Access Compliance Report

Public Rights-of-Way

(Curb Ramps)

Intersection ID: 29775	Main Street: KNIGHT_CASTLE_DR	Cross Street: MORDRED_LN	Location: NE
ADA ID: D4FE130EF727	Ramp Type: PerpDiag	Initial Pass/Fail: Pass	Overall Compliance: No
Severity Score: 5.25			
Codes/Mitigation Info/Possible Solution		Field Measurements/Component Compliance

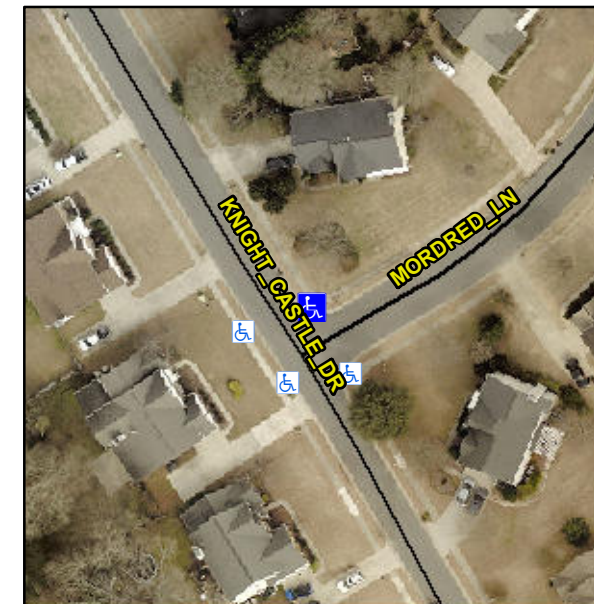
R304.5.3, R304.2.1, R304.2.2-Perp, R304.3.2-Para, R305.1.4, R305.2, R304.5.4

Compliance	Description	Data	Compliance	Description	Data
N/A	Ramp Length (in)	72.0	Yes	Ramp Slope (%)	5.6
Yes	Ramp Width (in)	48.0	No	Ramp XSlope (%)	3.9
N/A	Flare Type LT	Sloped	N/A	Flare Type RT	N/A
N/A	Flare Slope LT (%)	4.8	N/A	Flare Slope RT (%)	5.1
N/A	Flare Traversable LT?	No	N/A	Flare Traversable RT?	No
No	Landing Length (in)	39.0	Yes	DWS Provided?	Yes
Yes	Landing Width (in)	48.0	Yes	DWS Contrast?	Yes
No	Landing Slope (%)	3.3	No	DWS Length (in)	22.5
Yes	Landing X Slope (%)	1.9	Yes	DWS Full Width?	Yes
N/A	Landing Curb? (Y/N)	No	No	DWS Offset (in)	2.5
N/A	Shared Landing?	No			
Yes	Gutter Ponding?	No	No	Gutter Slope (%)	5.4
Yes	Gutter Lip Ht (in)	0.0	Yes	Gutter X Slope (%)	0.8
N/A	Painted X Walk1?	No	N/A	Painted X Walk2?	No
	X Walk 1 Direction	To NW		X Walk 2 Direction	To SE
N/A	X Walk 1 Width (in)	N/A	N/A	X Walk 2 Width (in)	N/A
	X Walk 1 Slope (%)	2.6		X Walk 2 Slope (%)	0.6
	X Walk 1 X Slope (%)	1.6		X Walk 2 X Slope (%)	0.2

N/A	Ramp inside XWalk1?	N/A	N/A	Ramp inside XWalk2?	N/A
	Road Slope (%)	1.5	N/A	Clear Space?	Yes
	Road X Slope (%)	2.3	N/A	Clear Space to XWalk (in)	N/A
Yes	Any Obstructions?	No	Yes	Storm Grate/Utility Hazard?	No
	Obstruction Type			Storm Grate/Utility Type	
		N/A			N/A
			Yes	Surface Condition? (G/P)	Good

Remove & Replace Curb Ramp With Two New Directional Ramps or Equivalent. Remove & Replace Gutter.
